DART AEROSPACE LTD.	- Work Order :	23882
Description 2010		
Description: 204 Skid Tube `l' Beam	Part Number:	D2597
Drawing Rof D0507 Day D		
Drawing Ref: D2597 Rev D	Qty:	3

**WORK ORDER**

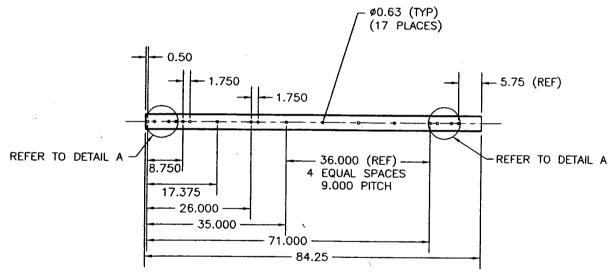
WORK ORDER CHANGES					
DATE S	STEP	PROCEDURE CHANGE	Ву	Date	Qty	Approval Mfg / Design Mgr	Approva QC Inspecto
5-08-17	Ч	Alodine Shevill be before the inspection to ensure produce i web is can pretect properly  permanent change Q	an.			De July 2007 LIN	2

NCR:		We	ORK OR	DER NON-CONFORMANCE	(NCR)			
		Description of NC	Corrective Action Section B			Verification	Approval	Approval
DATE	STEP	Section A	Initial Design Mgr	Action Description  Design Mgr	Sign & Date	Section C	Design Mgr	QC Inspector
05-06-11	2	Webs A to too short, webs were cut on the line.	O STOP 2	Acceptable this time.  drill sig was centered to web to compensate the 16 difference	05-8-11	Q-08:11	Newson?	05.68.11
								-
				·				
					·
